## Proposed Change 1831

<b>Code Reference(s):</b>	<b>NBC20 Div.B 9.36.2.5. (first printing)</b>
Subject:	Building Envelope - General
Title:	Insulation of Masonry Fireplaces
Description:	This proposed change clarifies the requirements for insulation of masonry fireplaces.

**Figure [A-9.36.2.5.(3)-A] A-9.36.2.5.(3)-A  
Masonry fireplace insulated within itself**

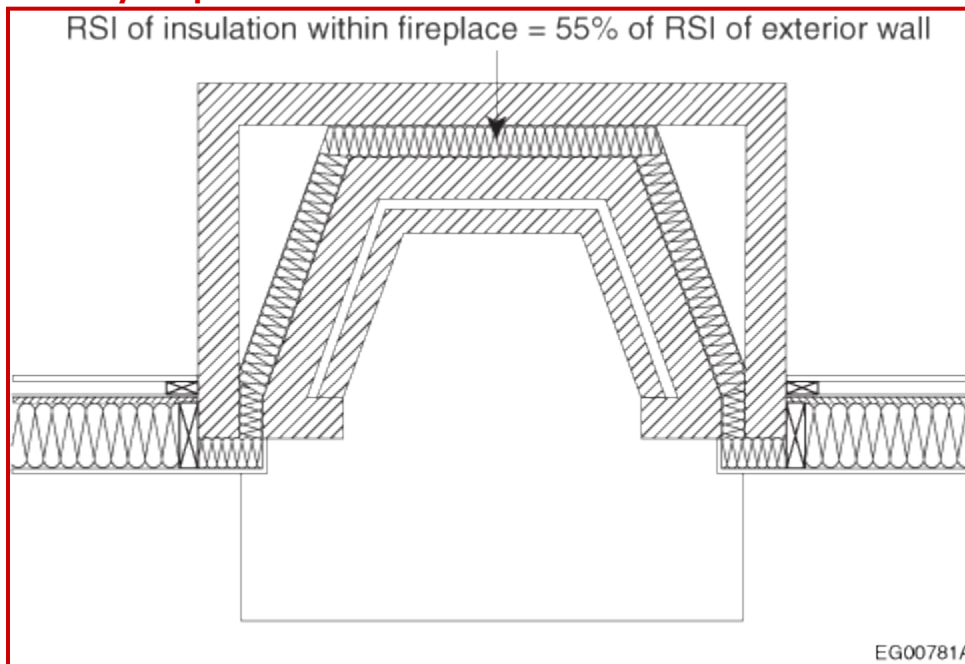
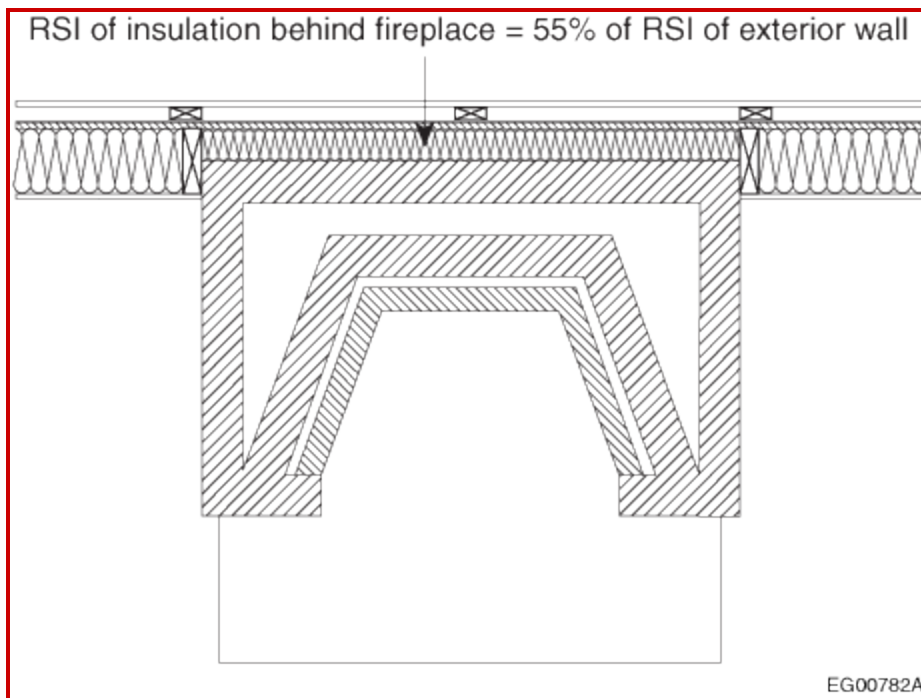
**Note A-9.36.2.5.(3) - Insulation of Masonry Fireplaces.**

The two insulation options for masonry fireplaces and flues presented in Sentence 9.36.2.5.(3) are consistent with those presented in Sentences 9.36.2.5.(2) and (4) with the exception of the option to insulate the sides of the penetrating element to 4 times the thickness of the penetrated wall, which would not be an energy-efficient option in cases where the penetration by the fireplace or flue is several feet wide. Figures A-9.36.2.5.(3)-A and A-9.36.2.5.(3)-B illustrate the options for achieving a continuously insulated exterior wall where it is penetrated by a masonry fireplace or flue.

**[3] 3)** Where a masonry fireplace or flue penetrates an exterior wall and breaks the continuity of the plane of insulation, ~~the fireplace or flue shall be insulated within the plane of insulation of the wall or within itself to an effective thermal resistance not less than 55% of that required for the exterior wall as stated in Table 9.36.2.6.-A or 9.36.2.6.-B (See Note A-9.36.2.5.(3).)~~

[a] --) be uninsulated.

[b] --) be considered as an opaque *building* assembly, and

[c] --) except as provided in Sentence (4), have an effective thermal resistance not less than 55% of that required for the exterior wall as stated in Table 9.36.2.6.-A or 9.36.2.6.-B.
